Sustainable Communities Environmental Assessment Errata

5001 Wilshire Project

Case Number: ENV-2021-3327-SCEA
DIR-2021-3324-CLQ, DIR-2021-3326-TOC-SPR-VHCA, VTT-83358

August 2022

FIGURE II-22

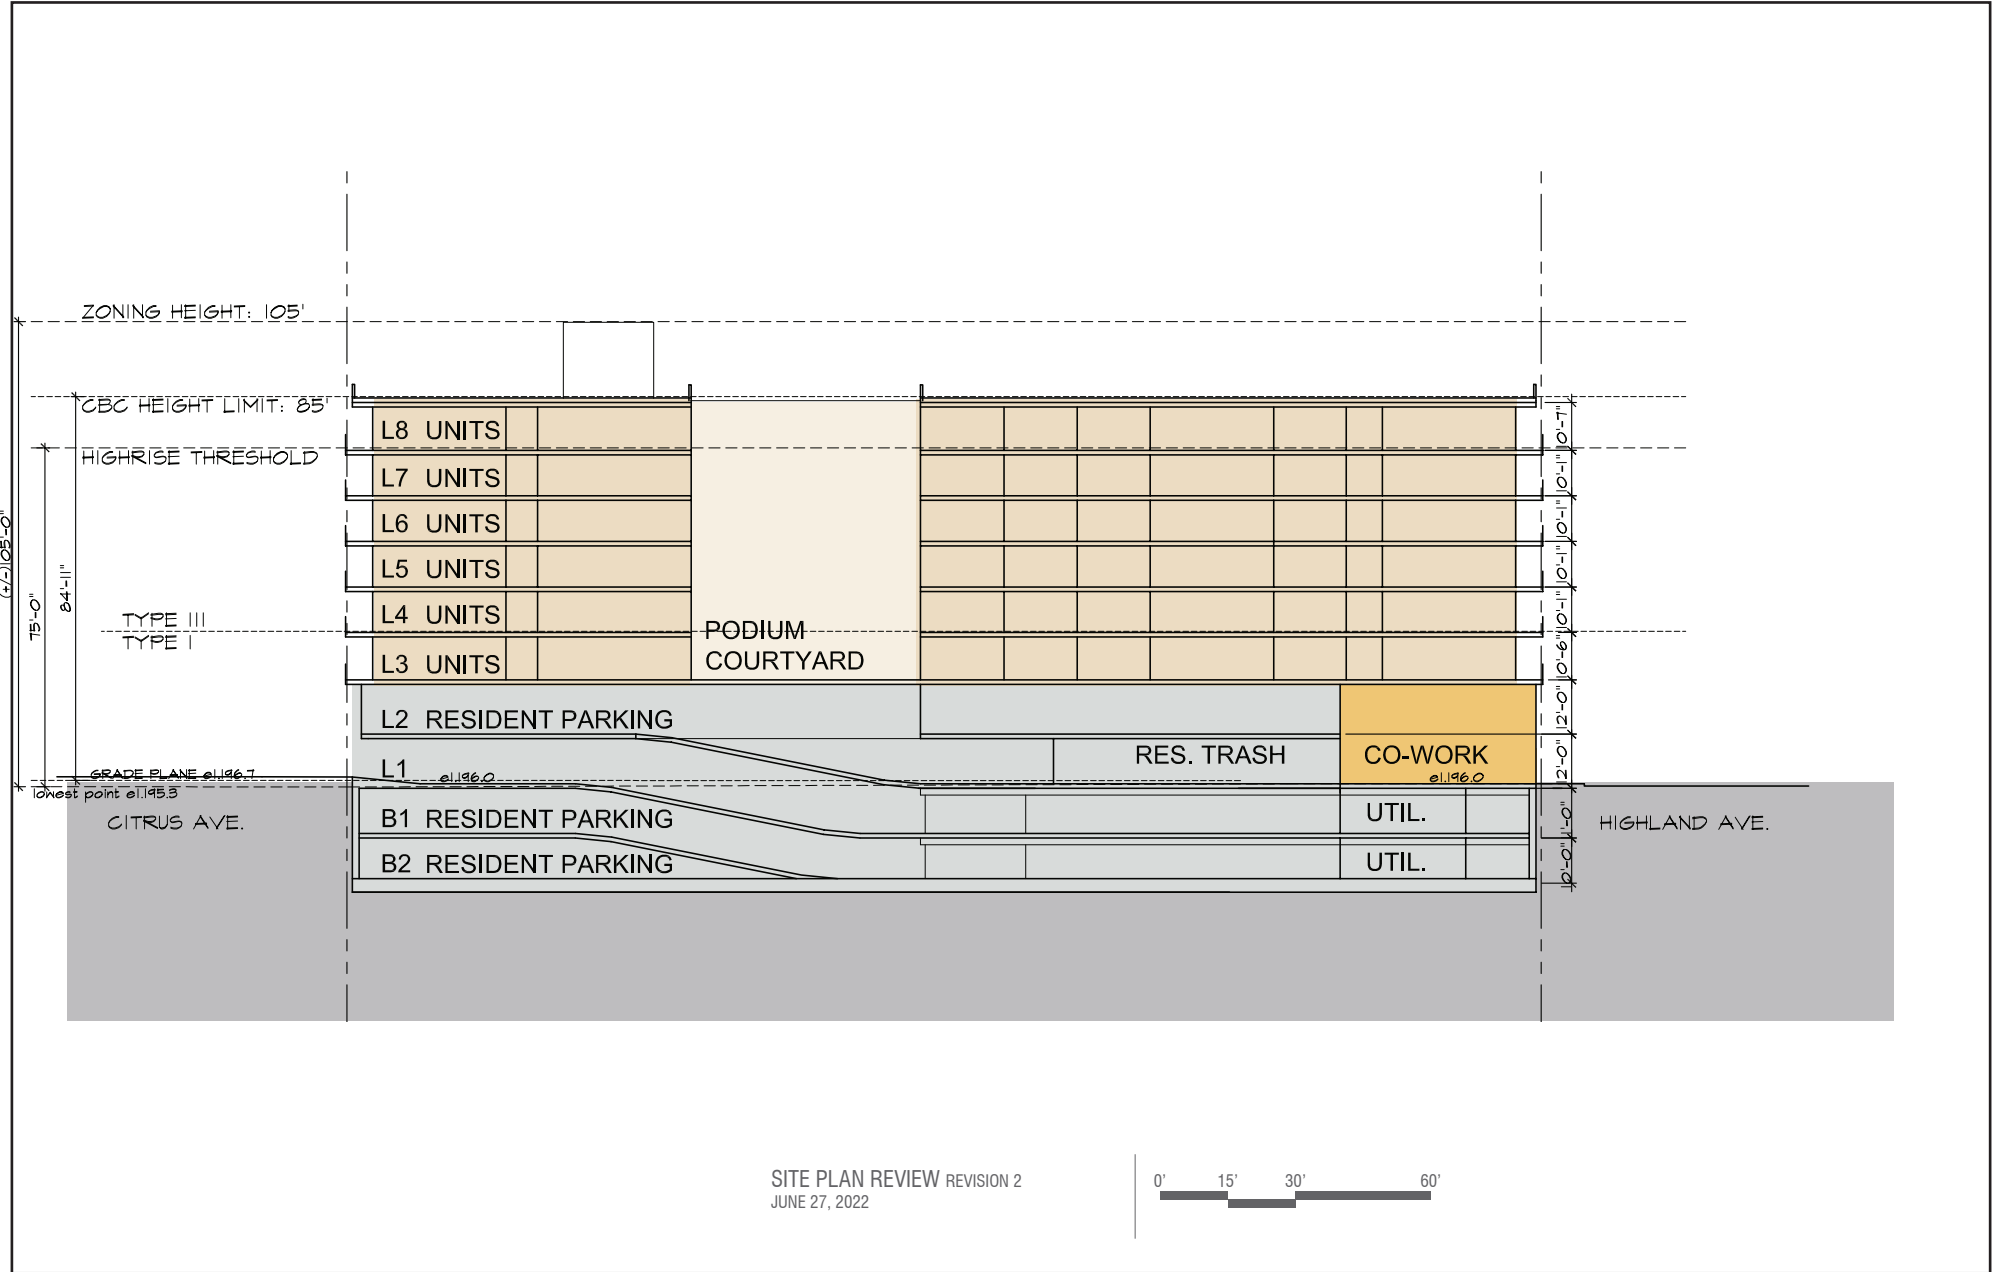
Figure II-22 Site Section A - this figure reflects the updates made to the building levels as a result of the elimination of the third subterranean parking level and the addition of the above-grade parking level.

FIGURE II-23

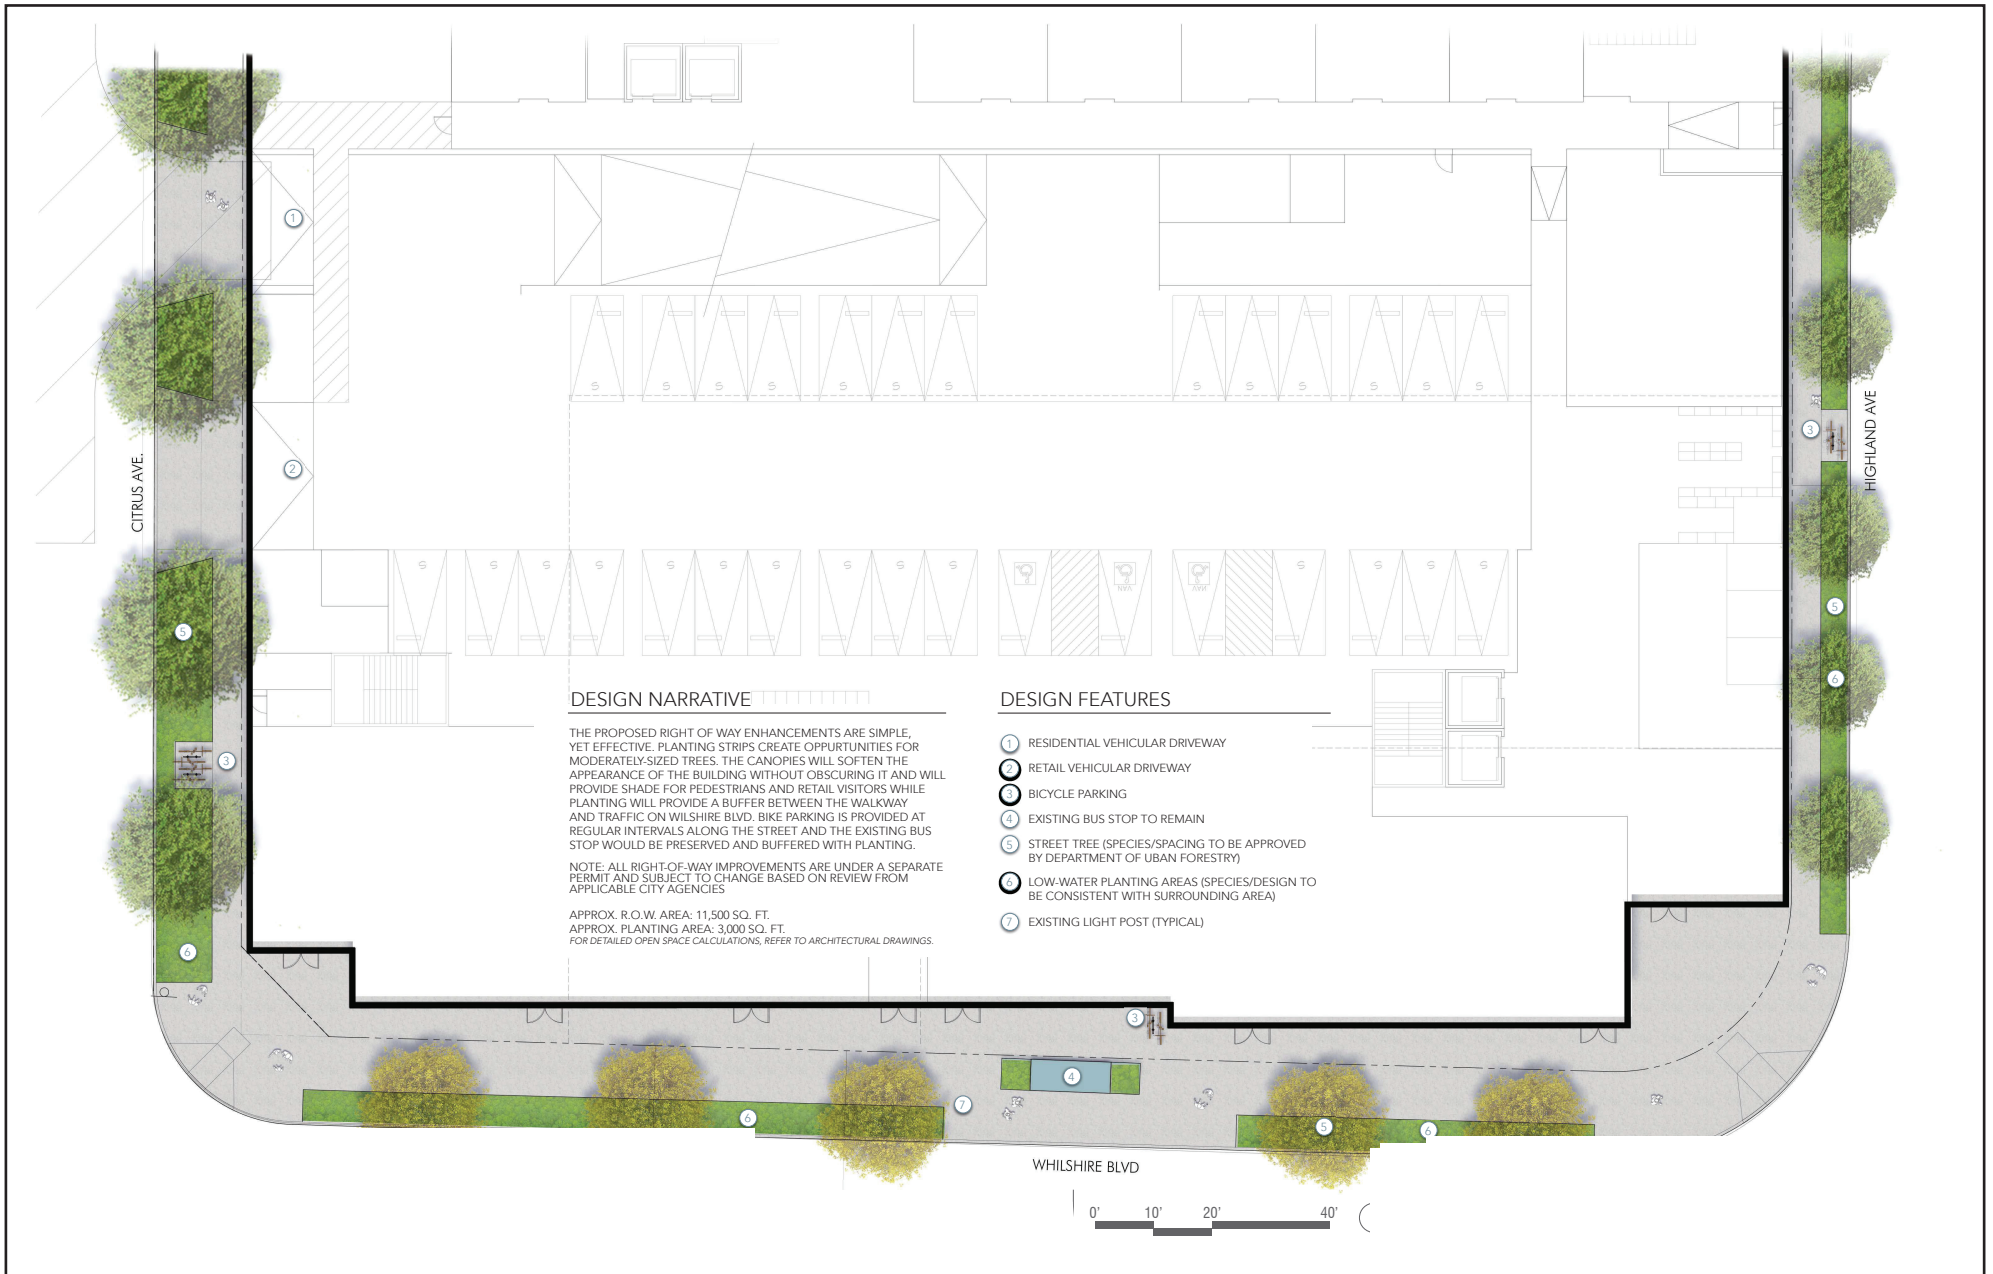
Figure II-23 Site Section B - this figure reflects the updates made to the building levels as a result of the elimination of the third subterranean parking level and the addition of the above-grade parking level, which also results in the reconfiguration of some storage areas and co-working areas.

FIGURE II-24

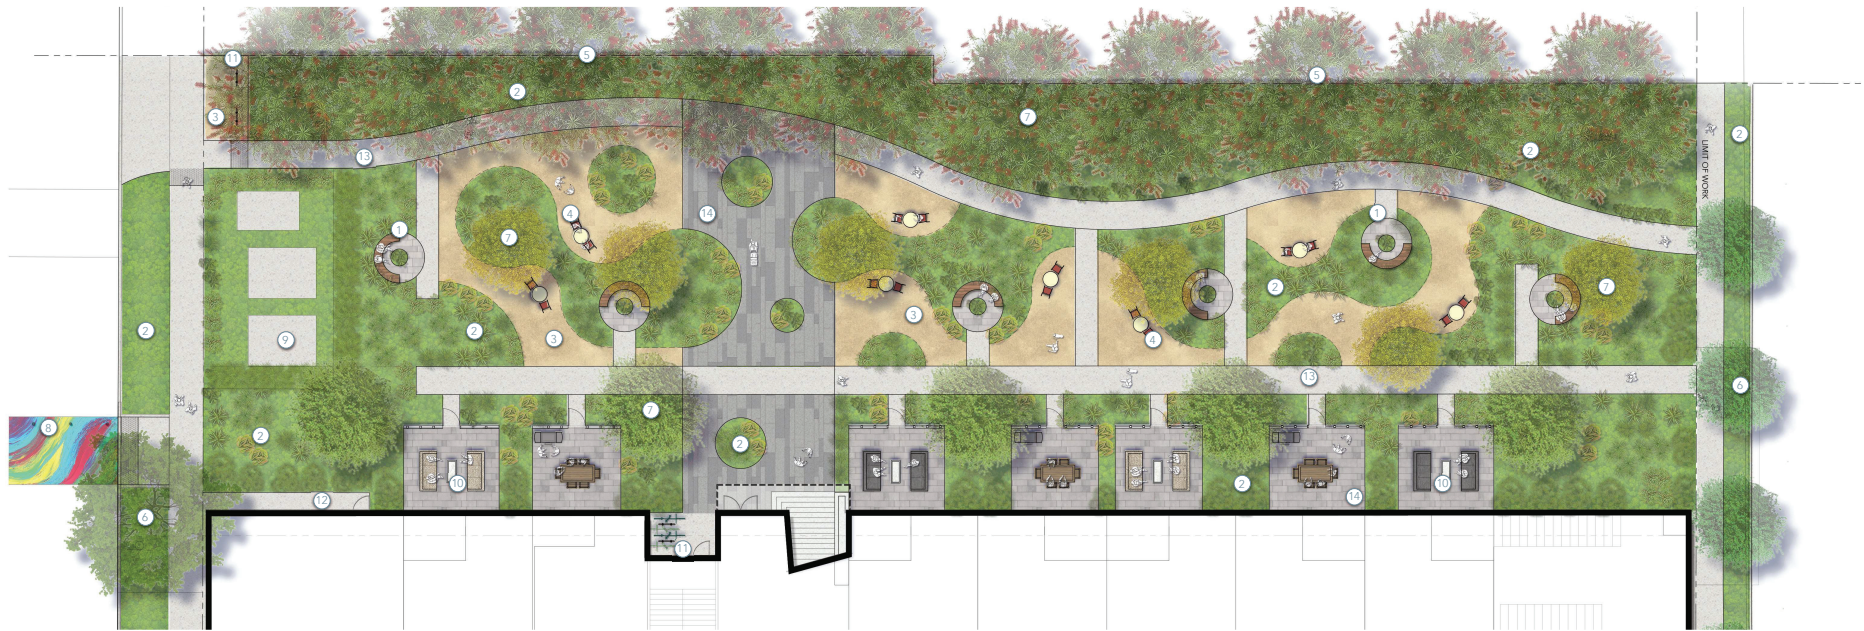
Figure II-24 Conceptual Right of Way Plan - this figure reflects the updates made to the configuration of the ground level (commercial) parking.

FIGURE II-34

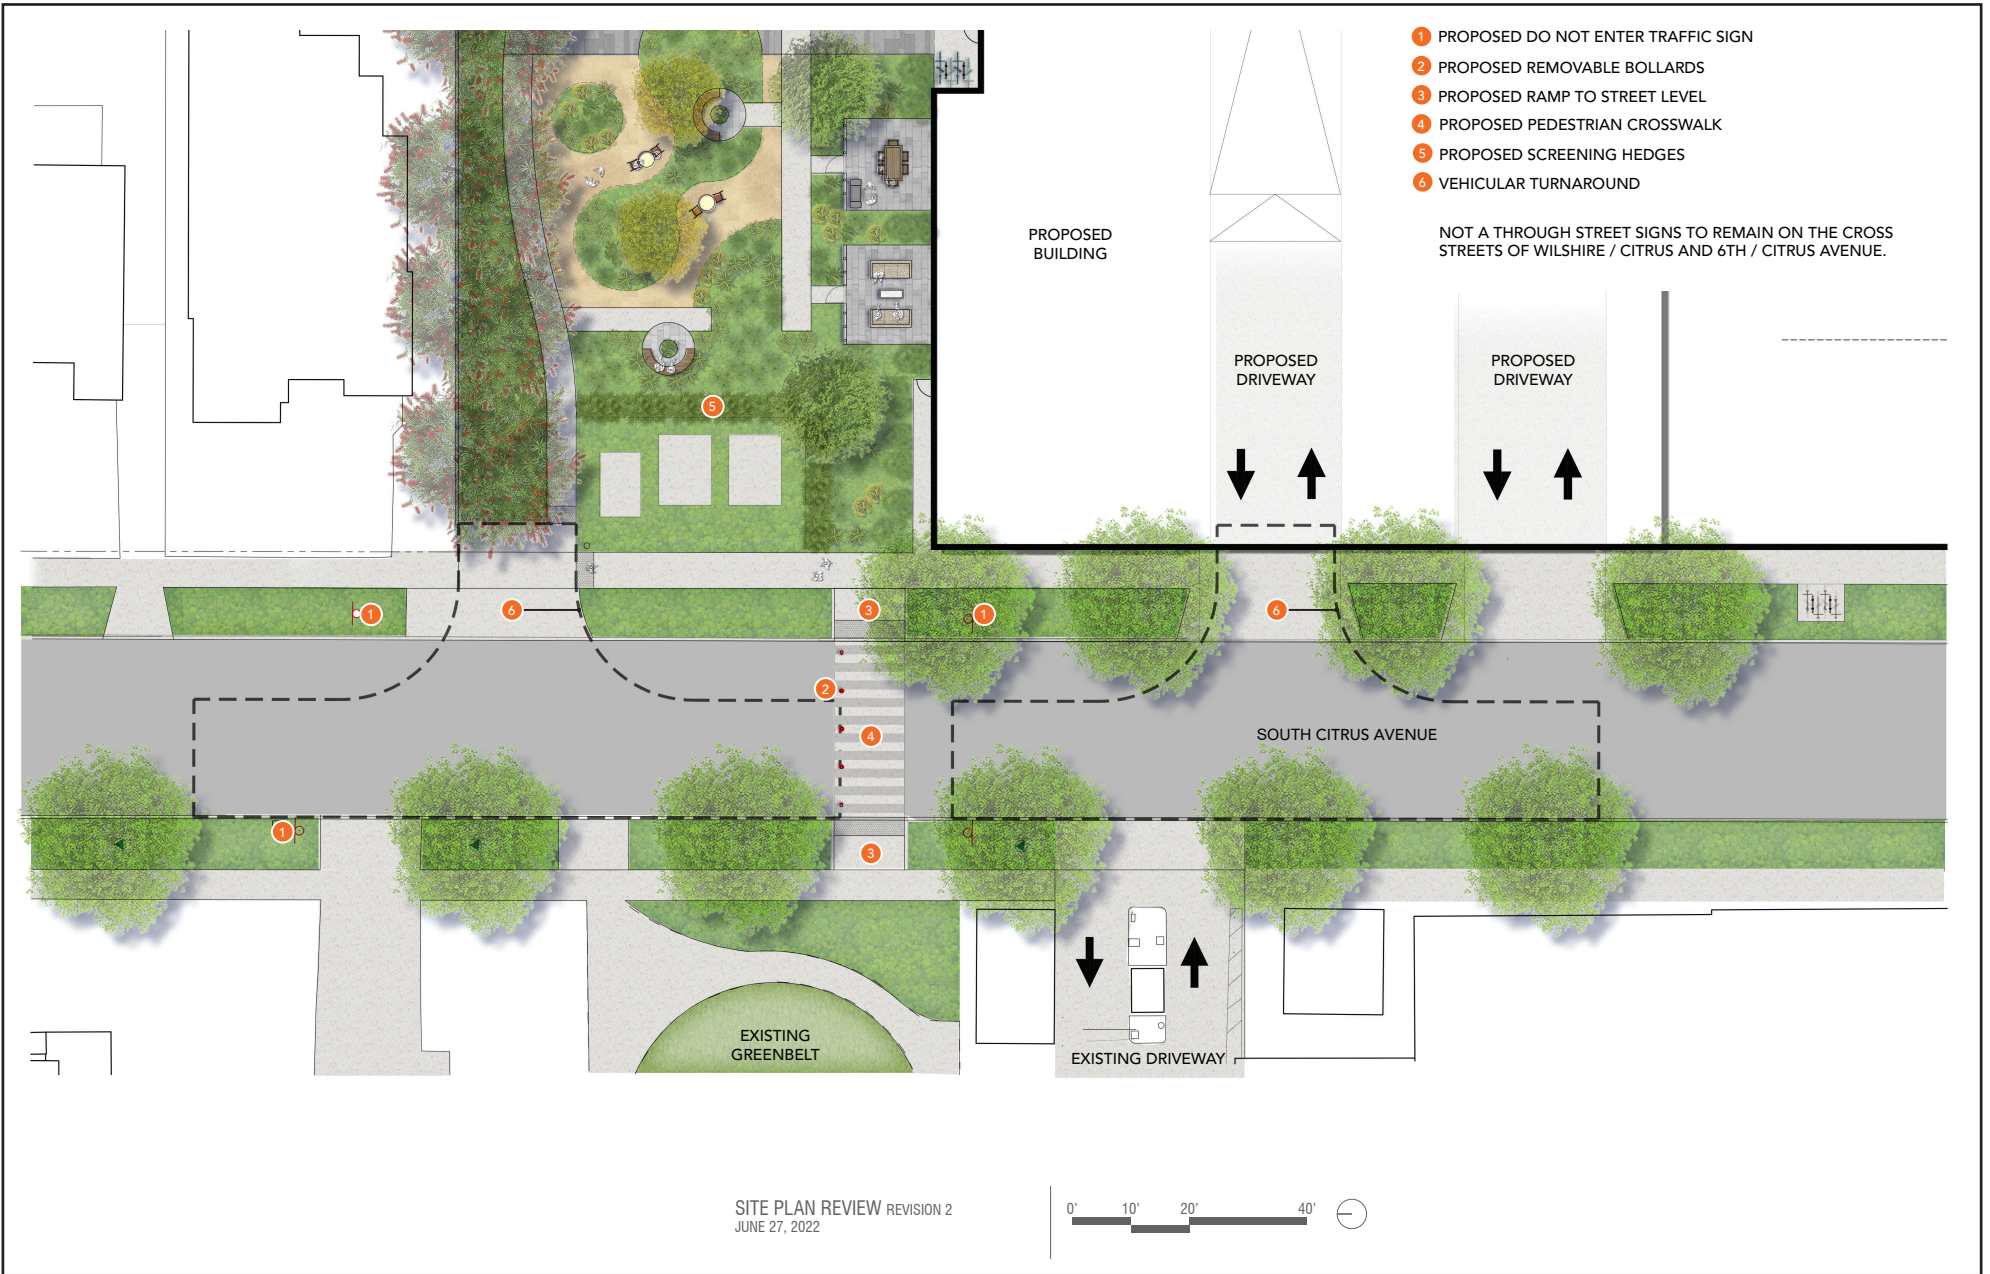
This figure was added to clarify the proposed design of the street crossing and illustrate the placement of signage and bollards on South Citrus Avenue; as included the analysis in the Transportation Assessment (Appendix H of the SCEA); this addition does not constitute new significant information, and does not change the analysis or conclusions in the SCEA pursuant to CEQA Guidelines Section 15088.5.
